Reference to No. 589 for revision the
estimate for the construction of a
building for the Board High School,
Bapalla, Kistna.

Recommending that a grant of Rs 3120/- may be sanctioned for the construction of a building for the Board High School, Bapatla, Kistna.

Note by the Chief Engineer, P.W.D.

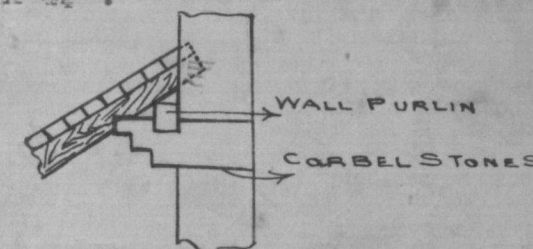
1. The floor provided for, is a very bad one for a School. It would be better to use plain Cuddapah slabs pointed with cement over 6" sand. The increase in cost will be about Rs.30 and is not much when compared with the superiority of the flooring obtained thereby.
2. The verandah rafters should not be let into the walls, but should be nailed to wall purlins supported at intervals of about 5½ feet on cut stone corbels as per sketch below. The section of the wall purlins should be 3" x 4½".
